On April 7, 2022 the Town of Bluffton Historic Preservation Commission approved the Certificate of Appropriateness to allow the construction a new 1.5 story single-family residence of approximately 4,120 SF and a Carriage House structure of approximately 1,188 SF located at 27 Bridge Street, in the Old Town Bluffton Historic District and zoned Neighborhood Conservation-HD (COFA-05-18-011989) with the following conditions:

Following the approval, an amendment application to add wood railings and gate to the front porch, change all double hung windows to casement windows (materials, size and location to remain as originally approved). As these items do not substantially alter the approval issued by the HPC, Town Staff as stamped revised sheets A3.0, A3.1 and A3.2 received 7/5/2024 and issued the amendment.

Re: Amendment Submittal for Nerhus Residence COFA-05-011989

THE NERHUS RESIDENCE  
27 BRIDGE STREET  
BLUFFTON, SC 29910

EXTERIOR  
ELEVATIONS  
A3.0

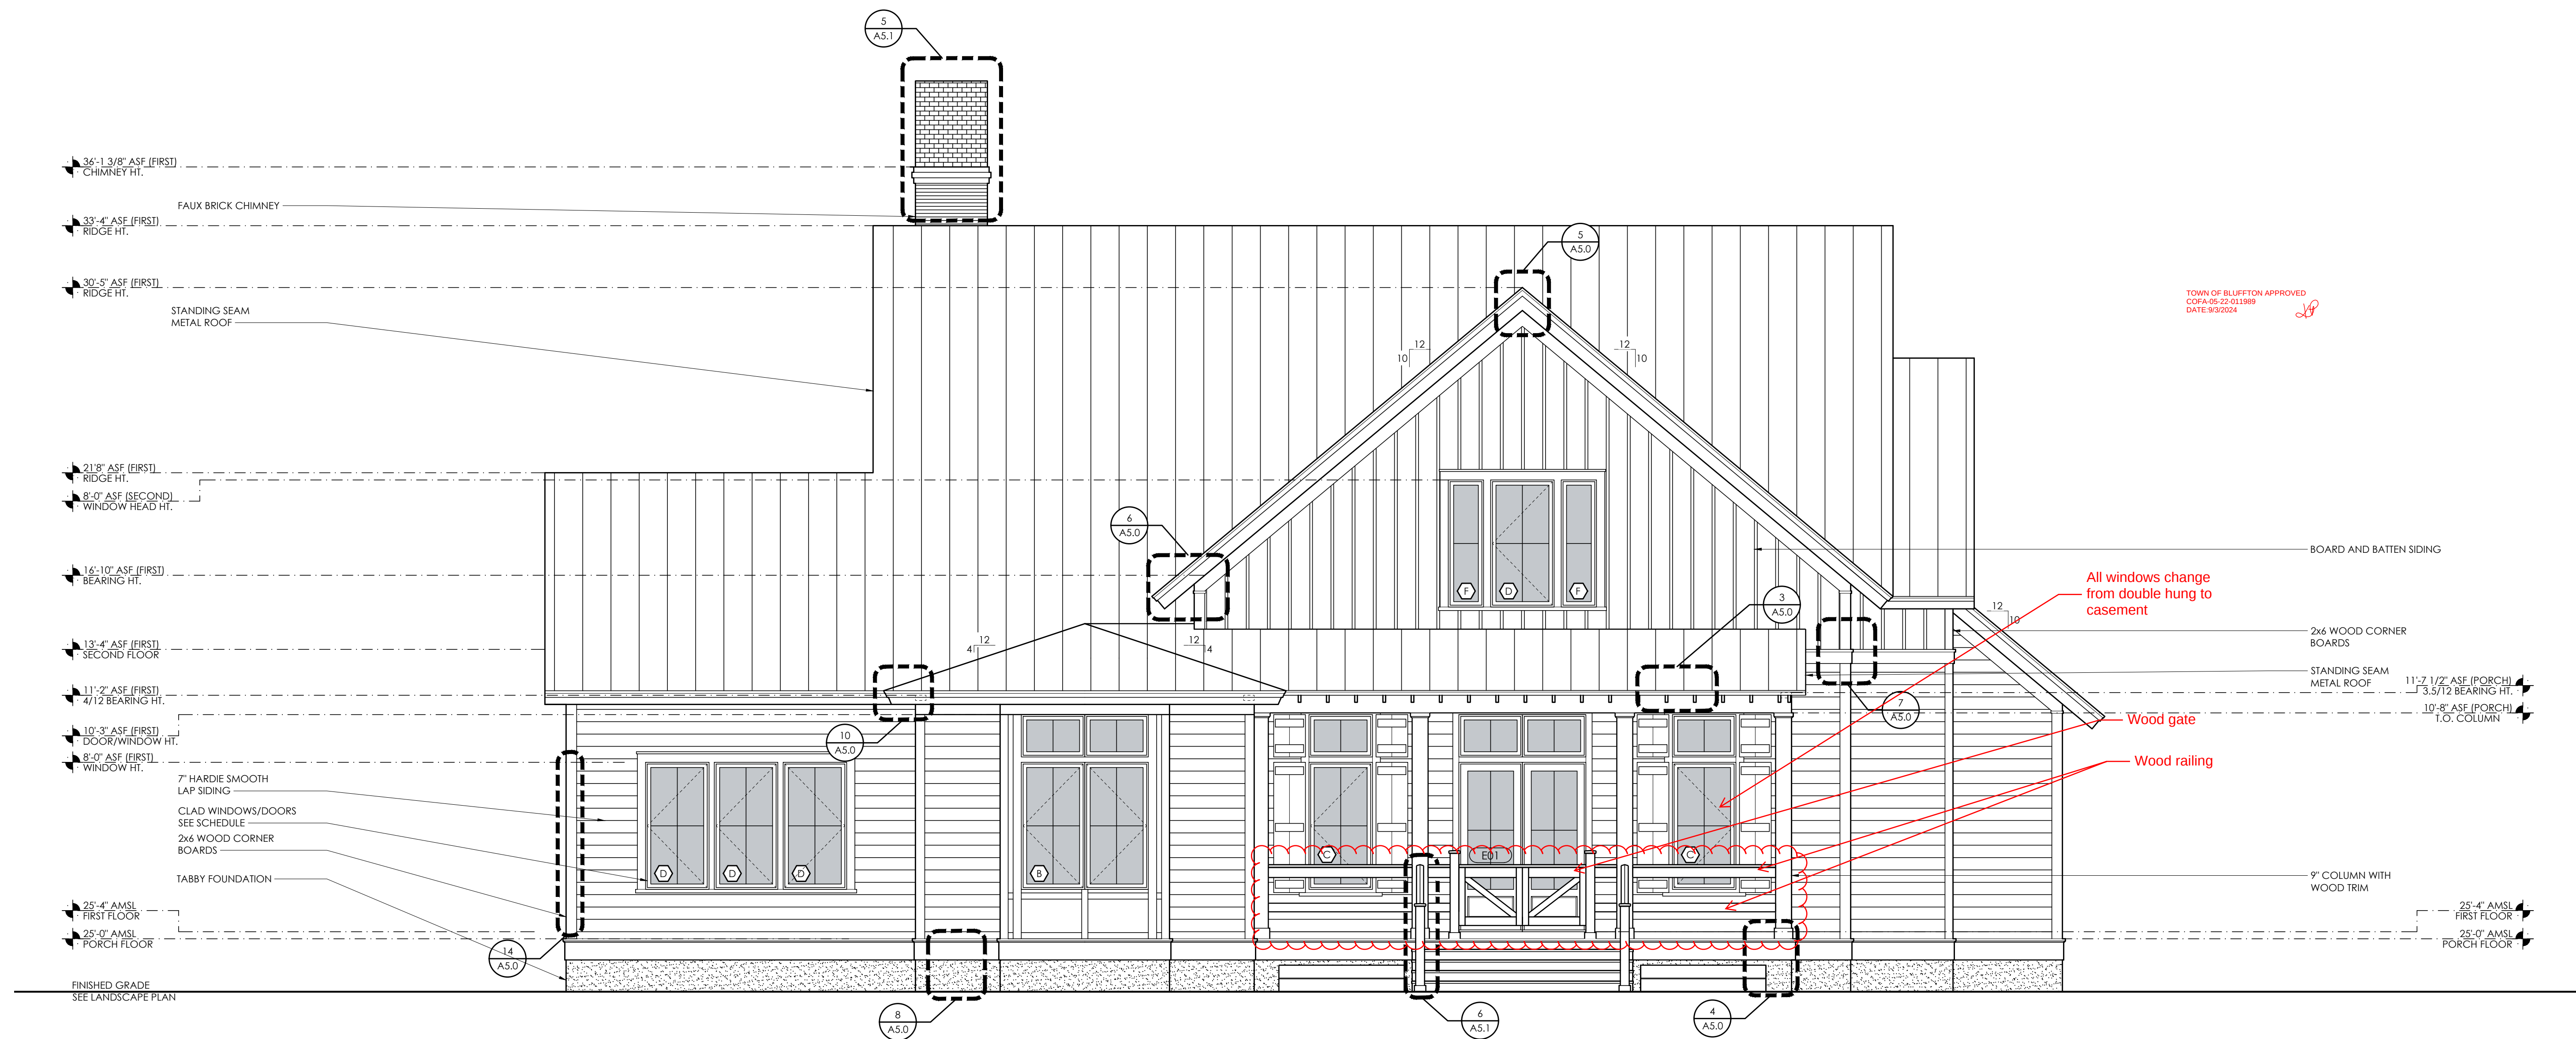
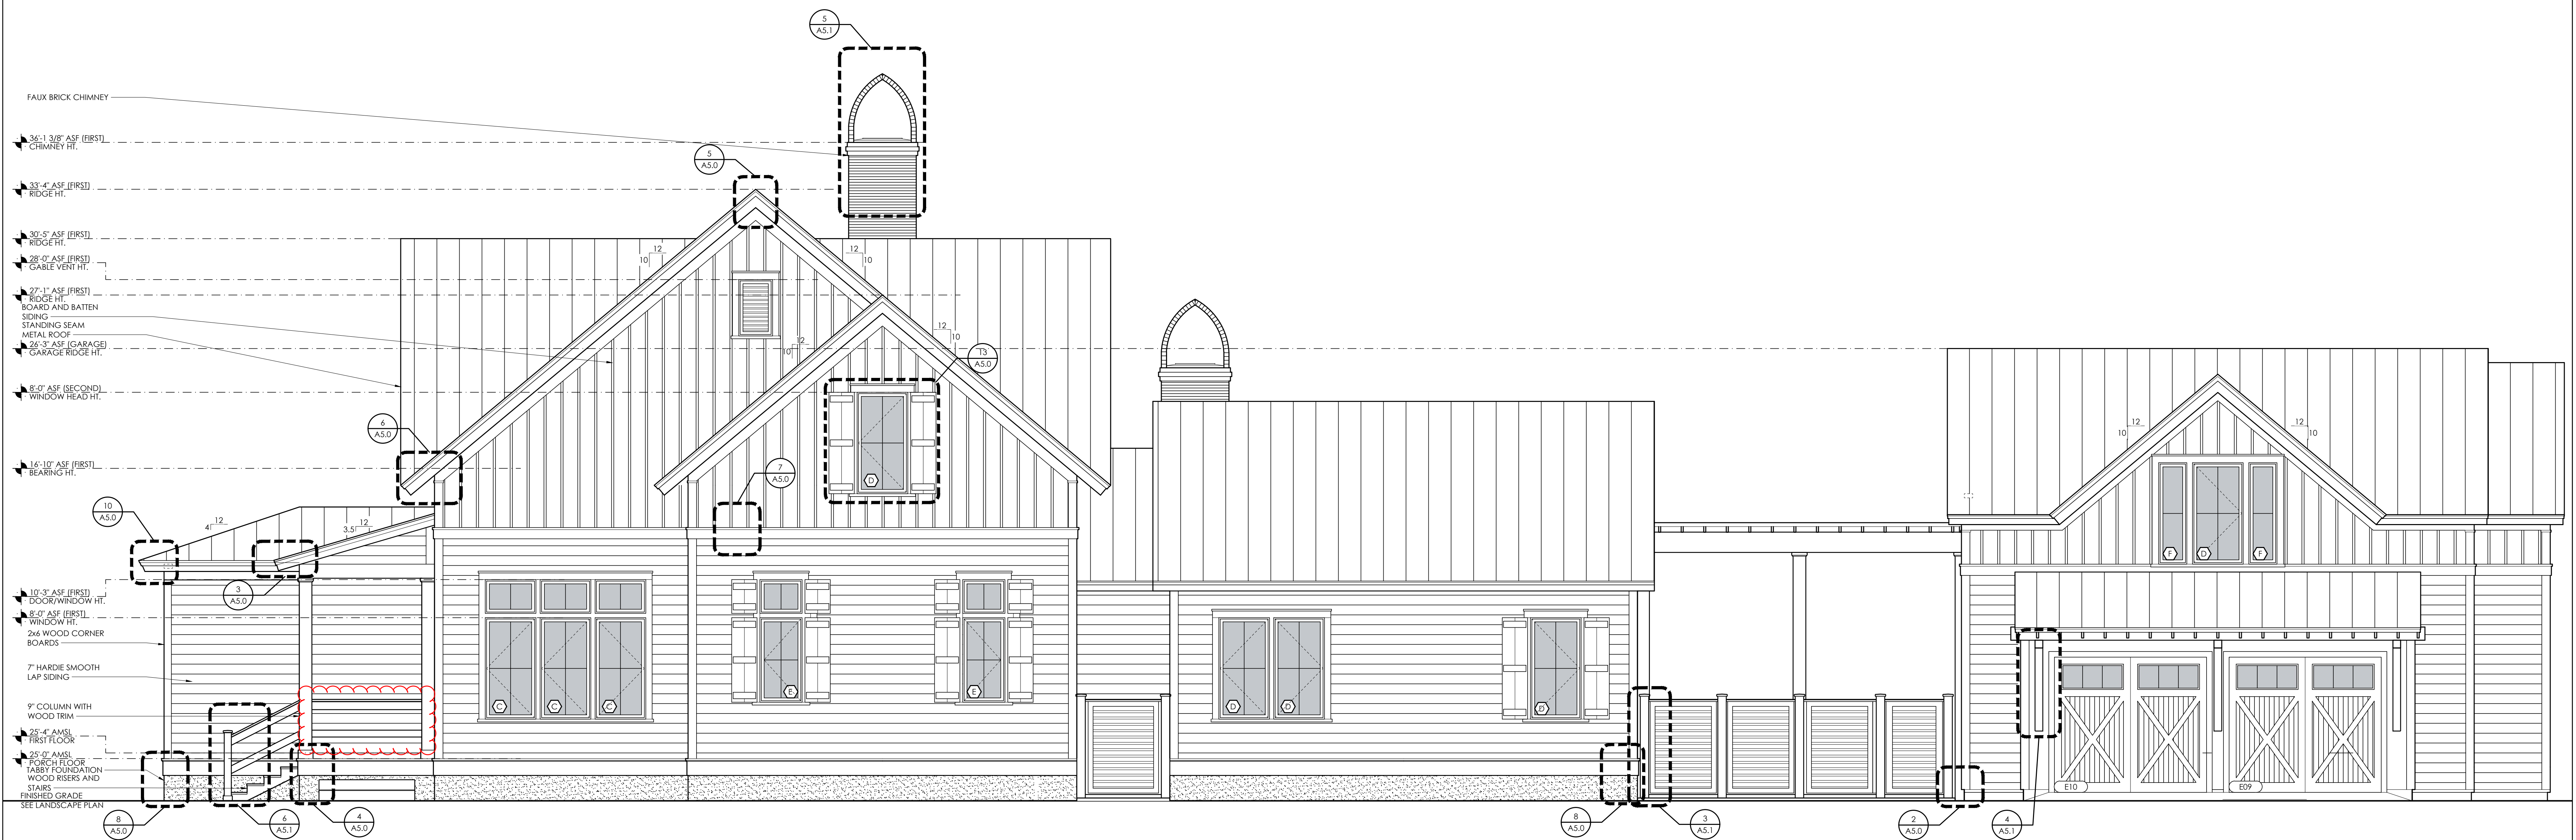
Please see attached documents for an amendment to the Nerhus Residence. Documents include application form and exterior elevations. Changes being submitted for review and staff approval are; adding to wood railing and gate to the front porch and changing out all double hung windows to casements windows (window opening / sizes and locations to remain the same and window material to be vinyl clad). If you have any questions or need any additional information please let me know.
